BROWNS FERRY NUCLEAR PLANT (BFN) - UNITS 1, 2, AND 3 -LICENSE RENEWAL APPLICATION (LRA) - SUPPLEMENTAL INFORMATION FOR OPEN ITEM 2.4-3 (TAC NOS. MC1704, MC1705, AND MC1706)

SUPPLEMENTAL INFORMATION FOR OPEN ITEM 2.4-3

A sketch of the BFN configuration of the refueling cavity to drywell seal is provided in Figure 1 of this enclosure.

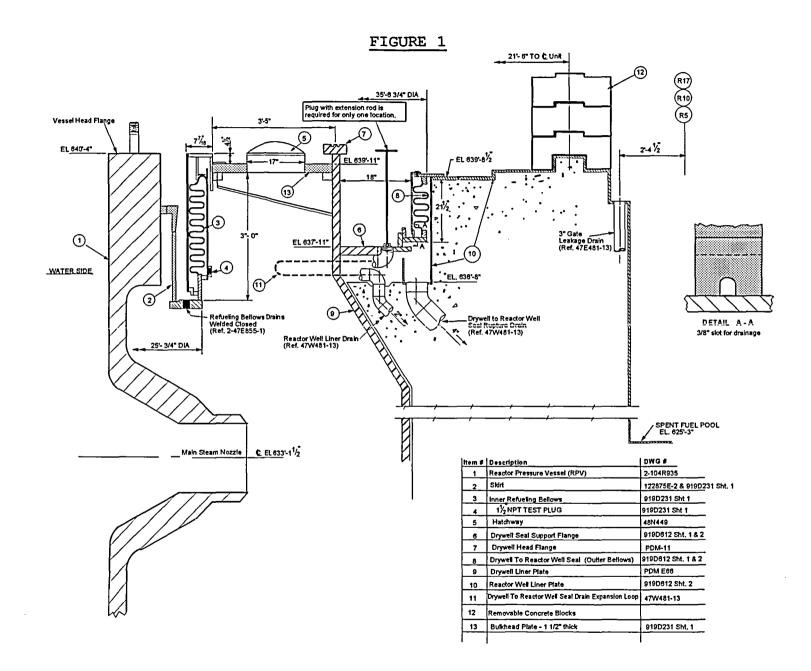
TVA stated that the BFN configuration of the refueling cavity to drywell seal is different from that of a number of other Mark I containments including the facts that there is no gasket at the drain, and the leakage from the refueling seal can be monitored. Please provide pertinent sketches to explain the above stated differences in seal configurations between BFN and other Mark I plants cited above and explain how the leakage of refueling seal is monitored as well as the reliability of the monitoring set up.

Regarding the walkdown performed in April 1998 at Unit 3's refueling seal area near the dry well flange (refer to TVA letter dated May 31, 2005), it was reported by TVA that standing water was observed. Please discuss the specific areas affected with the aid of sketches depicting the circumstances and the specific remedial action(s) taken. Also confirm if similar standing water experience was observed for Units 2 and 3 (Should be Units 1 and 2).

The BFN configuration was compared to the Oyster Creek drywell to cavity seal configuration which contained a 2" drain line which uses a gasket. As shown in Figure 1, the BFN configuration for the 2" drain line does not use a gasket. For BFN, this 2" drain line is welded to the plate. Using a weld connection eliminates the concern of gasket degradation which could result in water leakage during refueling operations. Also, as can be seen in Figure 1, any leakage from the Drywell to Reactor Well Seal (Outer Bellows), which is Item 8 in the figure, will go directly to the Drywell to Reactor Well Seal Rupture Drain and not to the inaccessible area of the drywell shell.

Referring to Figure 1, the standing water was located between the outside of the Drywell Shell (Item 9) and the Outer Bellows (Item 8) above the Drywell Seal Support Flange (Item 6) at Elevation 637'-11". This area is routinely flooded for shielding and contamination control during refueling operations. After refueling operations are completed, water may be left in this refueling seal area for shielding. As stated in the May 31, 2005, letter, this area is exposed to standing water and repeated wetting and drying during refueling operations. The area is not accessible for detailed visual examination from the outside surface.
